RE: Amended Soil Waste Management Plan Rock River Sediment Removal Project Janesville, Wisconsin BRRTS Activity # 02-54-577951

EnviroAnalytics Group, LLC (EAG) received a copy of your August 6, 2018 Response to Amended Soil Management Plan letter to Jaines LLC. EAG is pleased to submit the following responses to your comments. These responses have been numbered 1 through 7 to correspond with the comments presented in your letter.

FIGURE 5 BENEFICIAL REUSE LOCATIONS - TRUCK BAY FILL AREAS GM Janesville Assembly Plant 1000 General Motors Drive Janesville, Wisconsin

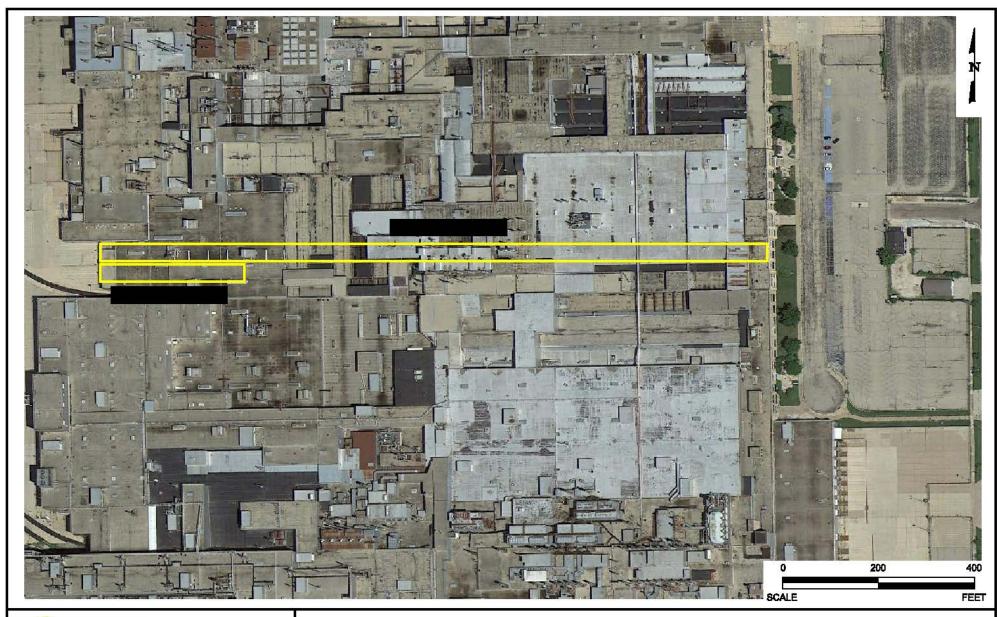
- 6. The locations of the two reuse areas are presented in several figures in the SMP. These figures are attached to this letter for ease of review. The vegetative area is located immediately west of the dewatering operations. The area is approximately ³/₄-acre and is mostly exposed soil with some vegetation.

- The truck bay areas were used to load and unload trucks as part of the former General Motors Assembly Plant operations. The bays are approximately 36-feet wide, 4-feet high and lengths of 1500-feet and 300-feet. The above ground structures that make up the assembly plant are currently being demolished and it is the intent of the owner to leave all existing slabs in place. The dewatered sediment material designated for this area will be used to fill the truck bays and the material will be capped with concrete to match the existing slabs and prevent risks associated with direct contact.

FIGURE 6 SOIL WASTEMANAGMENT PLAN - DECISION DIAGRAM 1000 GENERAL MOTORS DRIVE

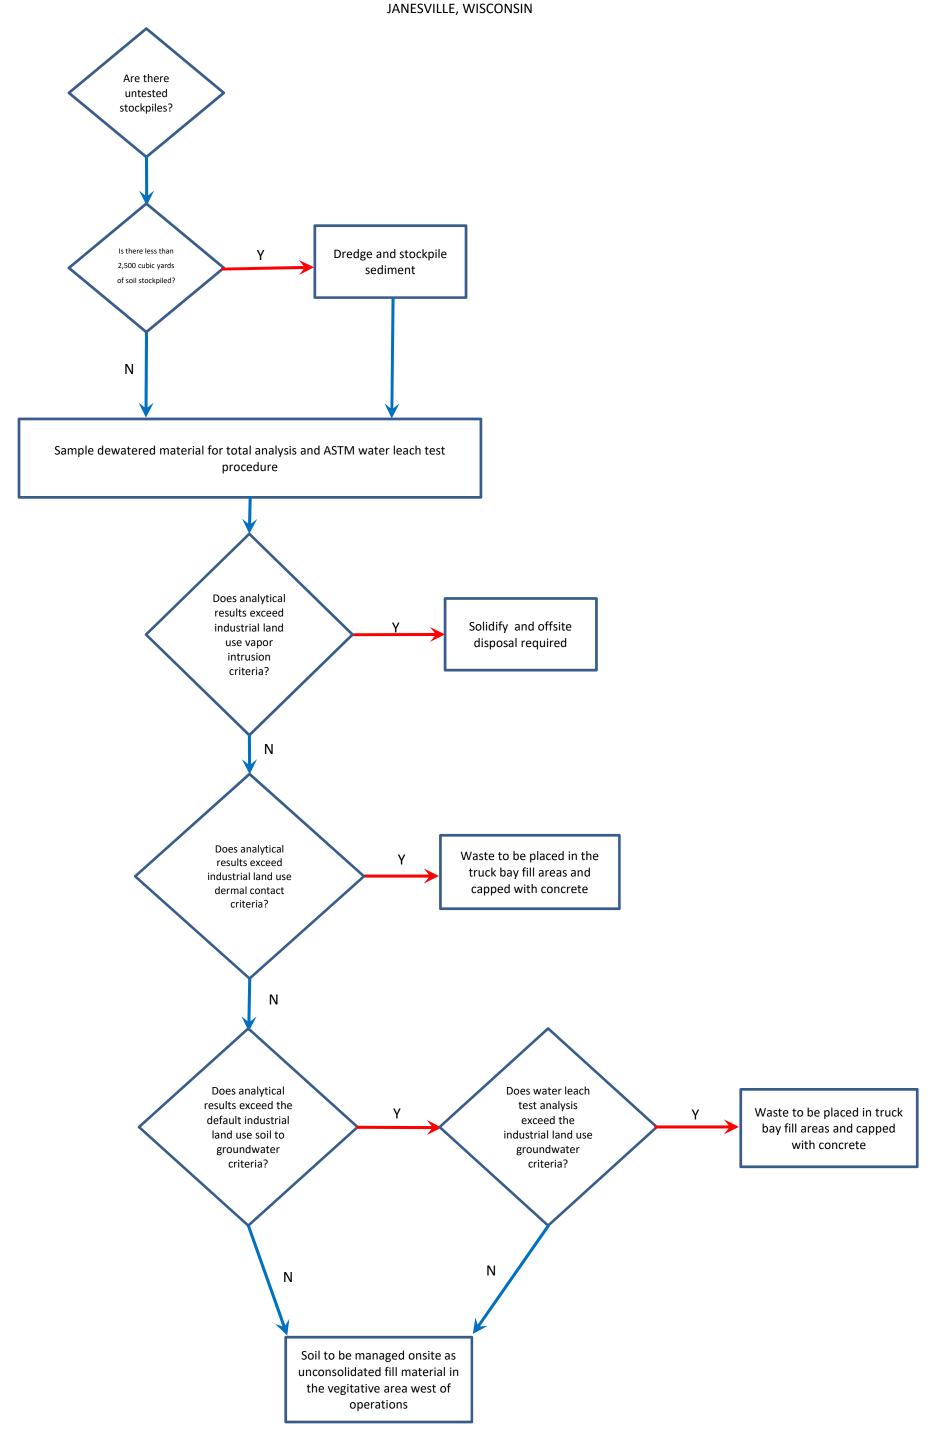
- 3. The decision diagram for the Soil Management Plan is attached. This diagram details the requirements for soils to be reused within the vegetative area to the west of the operations, the truck bay areas, and offsite disposal. The parking lot area north of the tire building is no longer considered a beneficial reuse location. All references to "non-residential" criteria have been removed from the sections detailing the Storage of Excavated Contaminated Soil and Reporting and the decision diagram and replaced with industrial residual contaminant levels (RCLs). It is the intent of the site owner to maintain the zoning of this property as industrial.
